ADNOC GAS
LONG TERM - EXECUTE STAGE
PROJECT 5.0 (P5)
EPCm FOR HABSHAN DBN
COMPANY PROJECT No. 30201-50150-LT-HE
WORK ORDER NO. 3000076501

Comments Resolution Sheet (CRS) - EPCm

COMPANY Trans. No.:	**ADNOCGP-WTRAN-024424**	**Received Date:**	**06-Feb-26**
COMPANY Doc. No.:	**30201_50150_LT_HE-H4-278-17-23-001**	**Revision:**	**B**
Document Title:	**UNIT 278 - HABSHAN 4FOUNDATION LAYOUT & DETAILS FOR IES-201FOUNDATION SECTION & RC DETAILS**	**Status Code:**	**Code 2**
ADNOC PM:	**Dr Azharuddin Mohammed**	**EPCm. CONTRACTOR PM:**	**Sriram PS**
ADNOC Reviewer:	**Mohamed Elsadani, Mr Kiranbhai Kuntmal, Mr Vinodhkumar Ranganathan**	**EPCm. CONTRACTOR Originator:**	**Surajit Das**

DRAWING TITLE: UNIT 278 – HABSHAN 4 FOUNDATION LAYOUT & DETAILS FOR 278-IES-201 BUILDING FOUNDATION LAYOUT

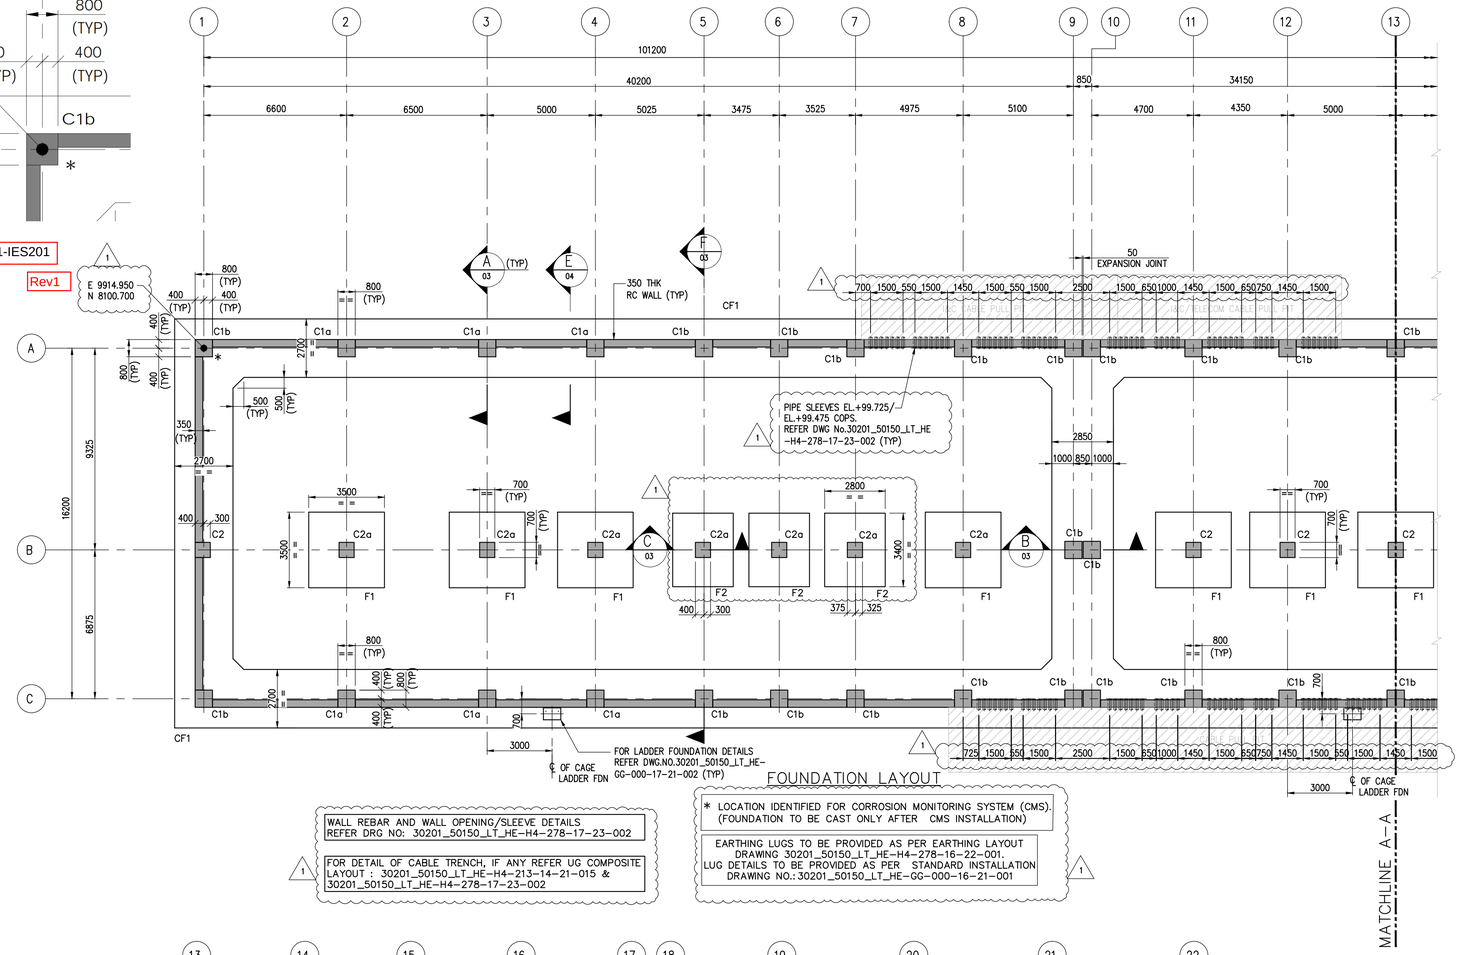
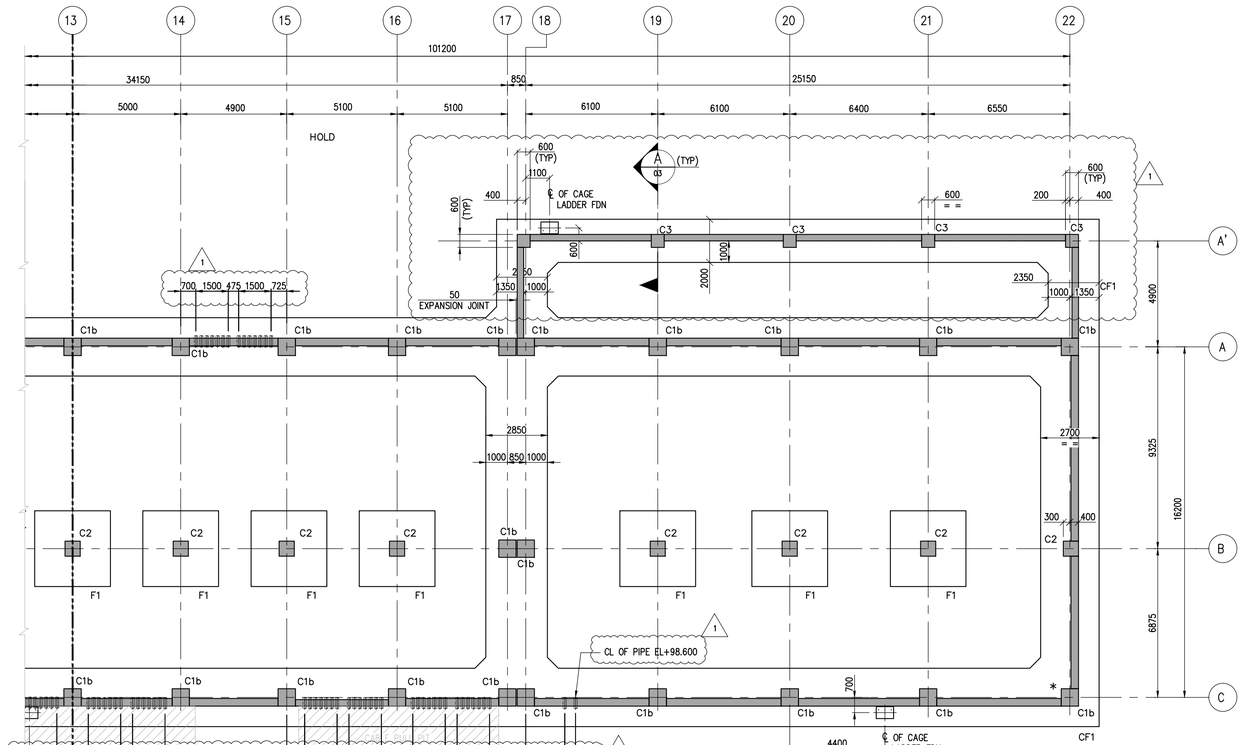
[1] 02	1. Update to mention Concrete grade, clear cover, rebar grade in a tabular format. 2. Update to include the MTO. 3. Update to mention the GWT in terms of levels. 4. Update to mention that : a) All concrete works shall be carried out as per addendum to AGES-SP-01-001. b) All earthworks shall be carried out as per AGES-SP-01-005 5. Earthworks shall also be based on the Geotech. recommendations. Ensure the same with Execute stage reports	Mr Vinodhkumar Ranganathan	1. Noted and updated. 2. Noted and updated. 3. Noted and updated. 4. Noted and updated. 5. Noted and updated.	Noted and closed						
	[1] 04	??	Mr Vinodhkumar Ranganathan	Noted and updated in Typical column RC details in Sheet 4.	Noted and closed						
	[1] 02	Align with CP vendor and update the notes suitably to GCC1	Mr Vinodhkumar Ranganathan	As CP vendor is not finalized . So it is kept under hold list.	Noted and updated	Not in the Hold list. Ensure to include in the Hold list	Noted and Updated.	Noted and closed

[1] 02	Expedite to clear the wall for construction minimum upto the Grade level at the earliest with all the openings and cut out. Update to provide the reference drawings	Mr Vinodhkumar Ranganathan	Noted and updated and wall opening is kept under hold list.	Noted.	This is must requirement to finalize the dowel rebars from foundation. Expedite to resolve the Hold at the earliest.	Noted and will be updated after receipt of wall opening input.Now it is mentioned I the hold list.				
	[1] 02	For this also, strip footing required ?? check and update	Mr Vinodhkumar Ranganathan	Notedand updated and the width is optimesed from 2000 mm to 1800mm.	Noted.						
	[1] 03	For strip foundation, Rebar plan layout and sections are mandatory showing the curtailments, lapping distance, locations etc. The shown rebar detail is very conservative. Update to provide the rebar details only as required with the suitable contingencies. With Wall from Footing, shown rebar design and details seems to be not okay.	Mr Vinodhkumar Ranganathan	Noted and updated.	Noted and closed

[1] 02	update to provide the rebar details at chamfer. Typical comment	Mr Vinodhkumar Ranganathan	Noted and already provided in sheet 4.							
	[1] 02	With intermediate column in place, column sizes considered seems to be high. Check and update as required	Mr Vinodhkumar Ranganathan	Retain column sizes to optimize the rebar requirement.	Noted and Closed.

DRAWING TITLE: UNIT 278 – HABSHAN 4 — FOUNDATION LAYOUT & DETAILS FOR 278-IES-201 FOUNDATION SECTION & COLUMN RC DETAILS

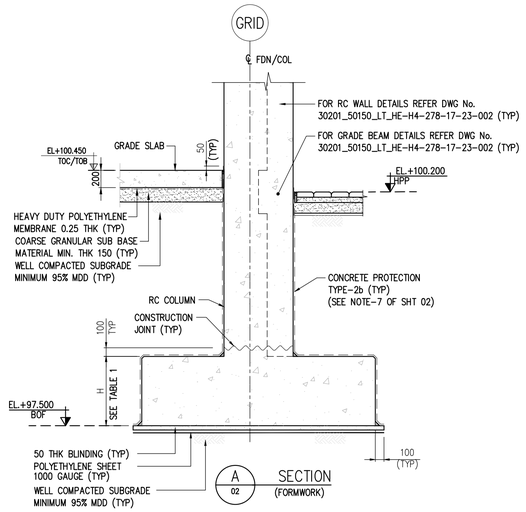
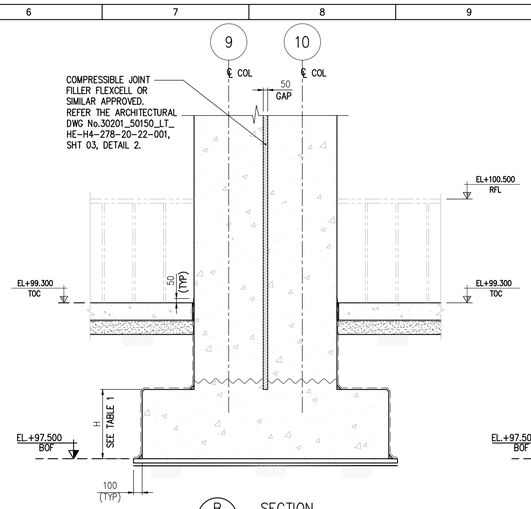
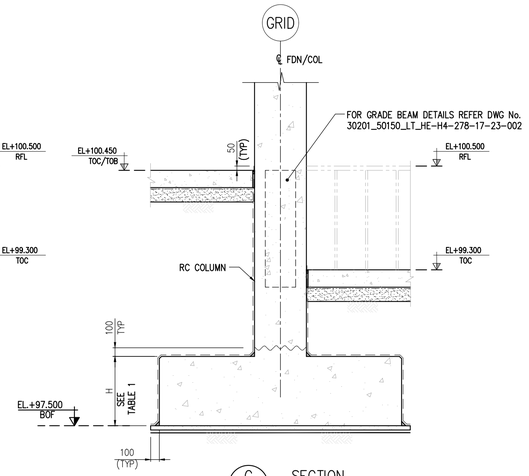
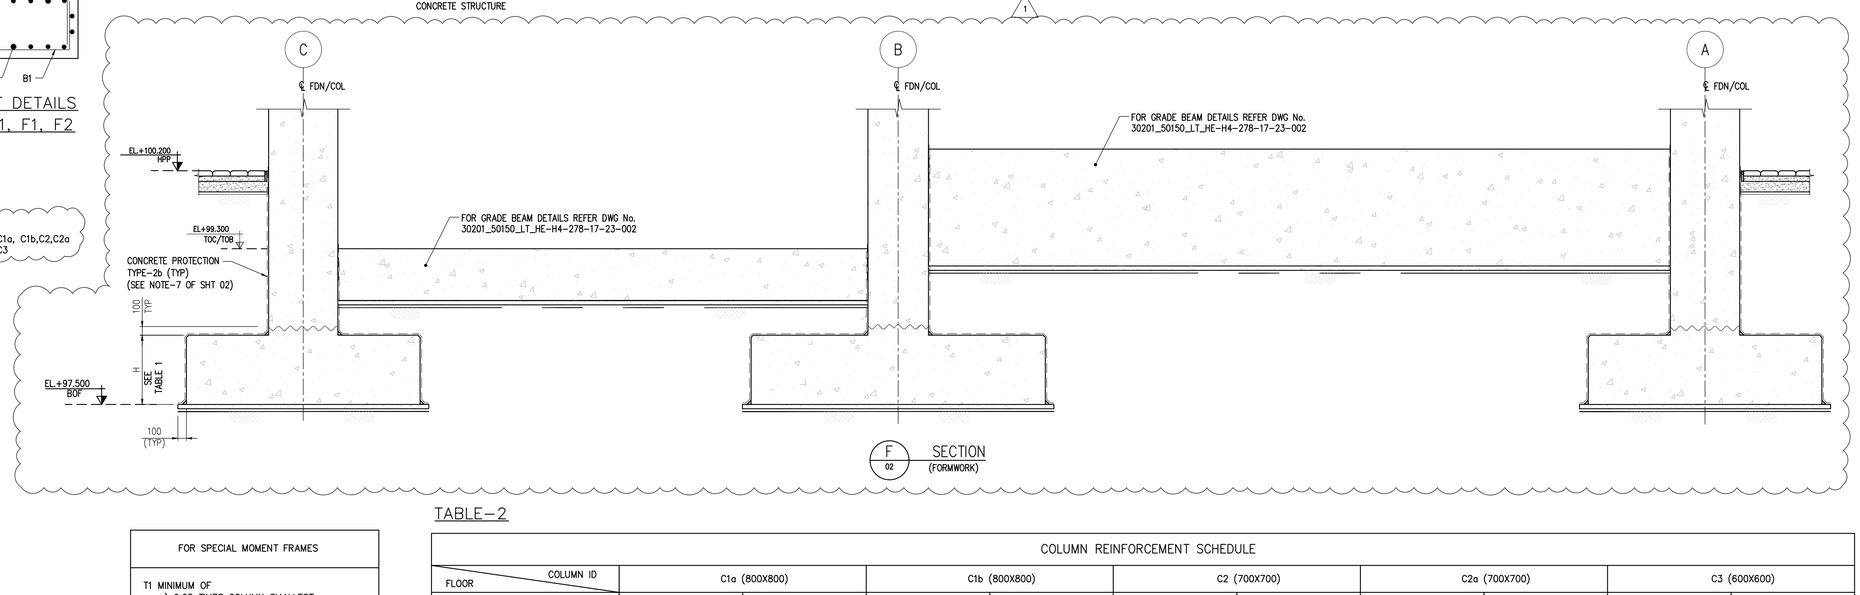
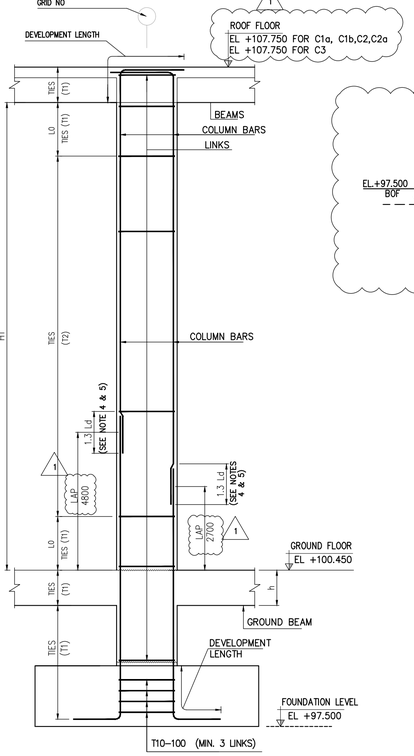
[1] 03	Also provide the reference on where to see the complete details and execute	Mr Vinodhkumar Ranganathan	Noted and updated. Architectural drawing 30201-50150-LT-HE-H4-278-20-22-001 referred for complte details	Noted and closed.						
	[1] 02	At the intersections and change in direction of strip footing, clear rebar detailing shall be provided to GCC1 to execute. Update. Typical comment.	Mr Vinodhkumar Ranganathan	Noted and updated.							
	[1] 02	Avoid multiple column Grouping with the same size. Check and update by having common rebar details.	Mr Vinodhkumar Ranganathan	Noted and updated.							
	[1] 02	check whether center line reference should be w.r,t wall or column as per structural modelling . Justify with the basis	Mr Vinodhkumar Ranganathan	Reference/ Grid line has been shifted at column centre.	Noted.	Ensure the offset requirements in STAAD. To be reviewed in design r	Noted and will be updated in the design document.	Noted .

[1] 03	For Top rebar, provided seems to be very high. check and update	Mr Vinodhkumar Ranganathan	Noted and optimized.							
	[1] 04	Highly recommend to consider the spacing at 100mm within the footing	Mr Vinodhkumar Ranganathan	Noted and updated.							
	[1] 03	Identify in the Plan	Mr Vinodhkumar Ranganathan	Noted and updated.							
	[1] 04	Only 50% shall be lapped at one point and other 50% shall be staggered. Exact location of lapping and staggering shall be shown for GCC1 to execute. Recommend to show full detail to GCC1 instead of typical detail. Discuss with GCC1 and update as required.	Mr Vinodhkumar Ranganathan	Necessary note has been provided in the drawing.							
	[1] 04	optimize the grouping	Mr Vinodhkumar Ranganathan	Noted and updated.							
	[1] 03	Please refer the E08 type standard earthing installation from drawing 30201_50150_LT_HE-GG-000-16-21-001 for REINFORCEMENT CONCRETE STRUCTURE	Mr Kiranbhai Kuntmal	Noted and updated.

No.	COMMENT SECTION/ CLAUSE / DRAWING REFERENCE	COMPANY Comment	COMPANY Reviewer	EPCm CONTRACTOR Response	Open/Closed	COMPANY Response (If Comments are still open / Not incorporated or if Eng Contractor Response Not Acceptable)	EPCm CONTRACTOR Response	Open/Closed			Remarks
	[1] 02	Ensure that the sealant is sufficient to accommodate the relative movement between the segments. Attach the check in the CRS and later include in the design report.	Mr Vinodhkumar Ranganathan	Max relative displacement is coming 8 mm which is less than 0.35X 50=17.5 mm .	Noted and closed						
	[1] 03	Include the detail number and sheet number	Mr Vinodhkumar Ranganathan	Noted and updated.							
	[1] 03	T12	Mr Vinodhkumar Ranganathan	Noted and updated.							
	[1] 03	External wall is concrete. update	Mr Vinodhkumar Ranganathan	Noted and updated.							
	[1] 03	T10 @ 100C/C	Mr Vinodhkumar Ranganathan	Noted and updated.

[1] 03	Maintain clear cover	Mr Vinodhkumar Ranganathan	Noted and updated.							
	[1] 03	Splicing locations shall be shown in Engineering drawings to GCC1. Update	Mr Vinodhkumar Ranganathan	Noted and updated.							
	[1] 04	T16	Mr Vinodhkumar Ranganathan	Noted and updated as 20 dia bar at bottom.							
	[1] 04	Shown is not correct. may be scaling issue. check and update	Mr Vinodhkumar Ranganathan	Noted and updated.							
	[1] 04	Horizontal rebars shall be in the external	Mr Vinodhkumar Ranganathan	Noted and updated.							
	[1] 04	Blast wall design for IES-201 to be concluded before the IFC of this drawing. Discuss in advance to avoid delay and reworks.	Mr Vinodhkumar Ranganathan	noted and updated as 350 mm thik wall.							
	[1] 04	Ensure bottom rebar splicing is always at centre. Typical comment	Mr Vinodhkumar Ranganathan	Noted and updated.							
	[1] 04	T16 ? Check the correctness and update as required	Mr Vinodhkumar Ranganathan	Noted and updated as 20 dia bar at bottom.

DRAWING TITLE: UNIT 278 – HABSHAN 4 FOUNDATION LAYOUT & DETAILS FOR 278–IES–201 FOUNDATION RC DETAILS

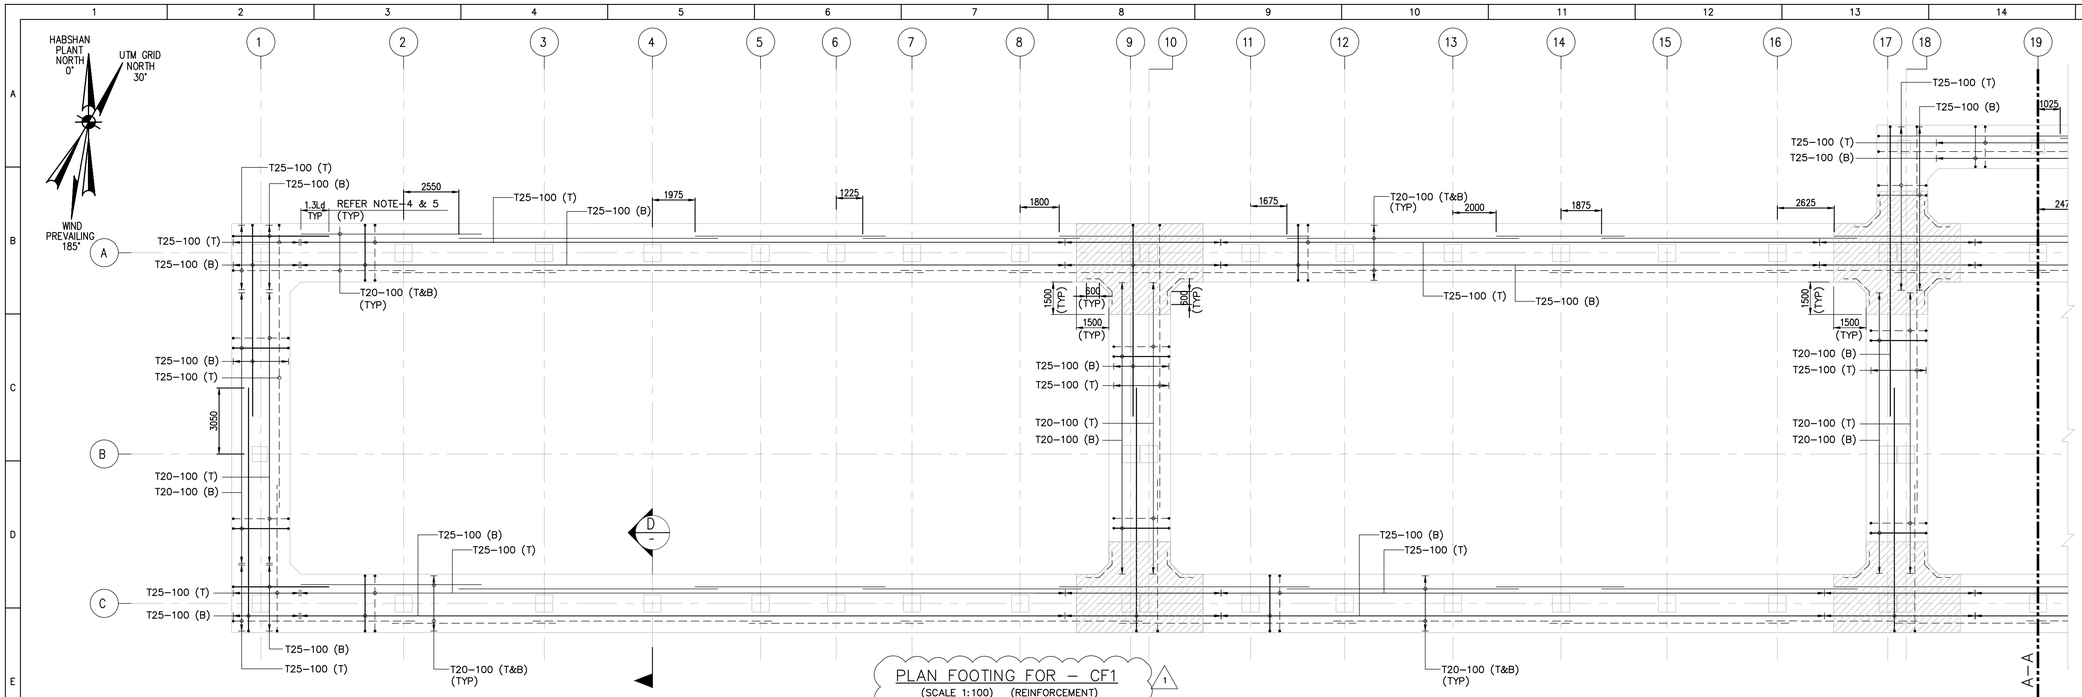
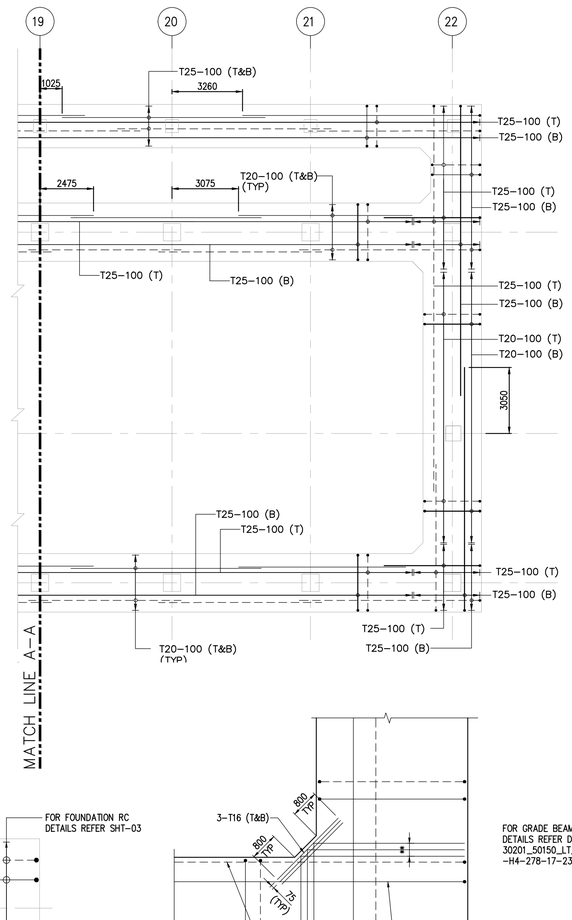
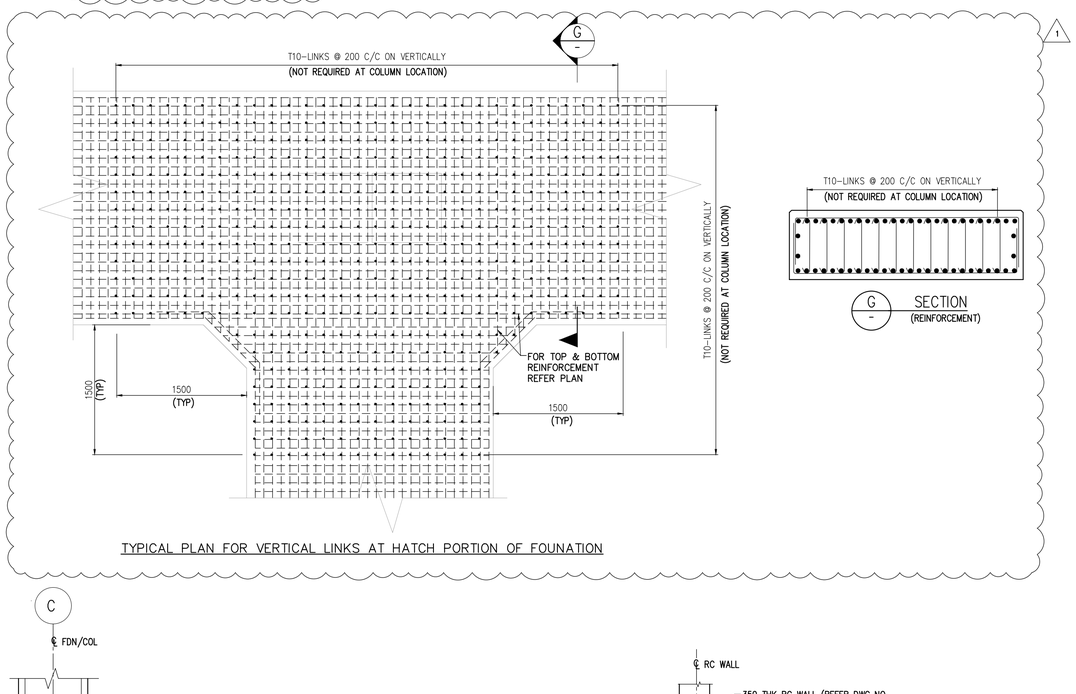
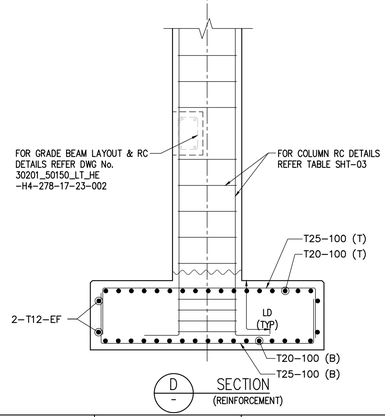
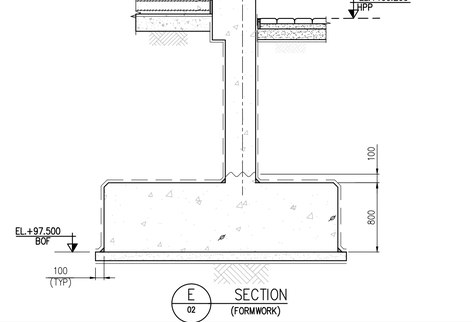
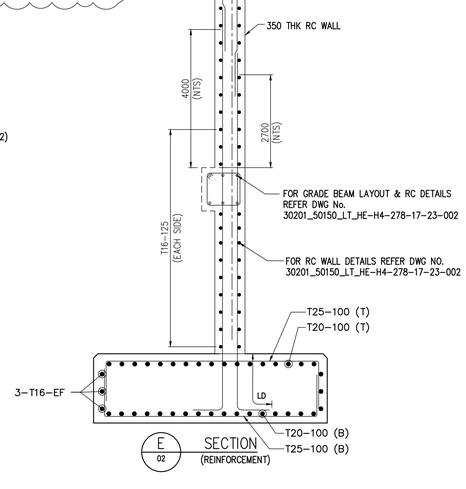
[1] 04	recommend to consider the rebar to shape	Mr Vinodhkumar Ranganathan	Detail retained as per issued drawings for other buildings.							
	[1] 03	Refer the comments on 30201_50150_LT_HE-H4-280-17-23-003 and update as require	Mr Vinodhkum Ranganathan	Noted and updaed as applicable.							
	[1] 03	Show earthing arrangement of steel reinforcement bars.	Mohamed Elsadani	For earthing lugs details refer drawing no 30201_50150_LT_HE-GG-000-16-21-001 And the earthing lugs location is under hold.							
	[1] 03	Side face rebars shall be considered with a spacing =< 300mm	Mr Vinodhkumar Ranganathan	Noted and updated.							
	[1] 02	The considered width seems to be more for IES building. Check and update	Mr Vinodhkumar Ranganathan	Noted and it is optimised from 3000 mm to 2700 mm.							
	[1] 03	Update to mention where to refer the grade slab details	Mr Vinodhkumar Ranganathan	Noted and updated with standard drawing of grade slab.

48	[1] 04	T20? For combined Top long rebar generally higher. check and update	Mr Vinodhkumar Ranganathan	Noted and updated as 20 dia bar at bottom.
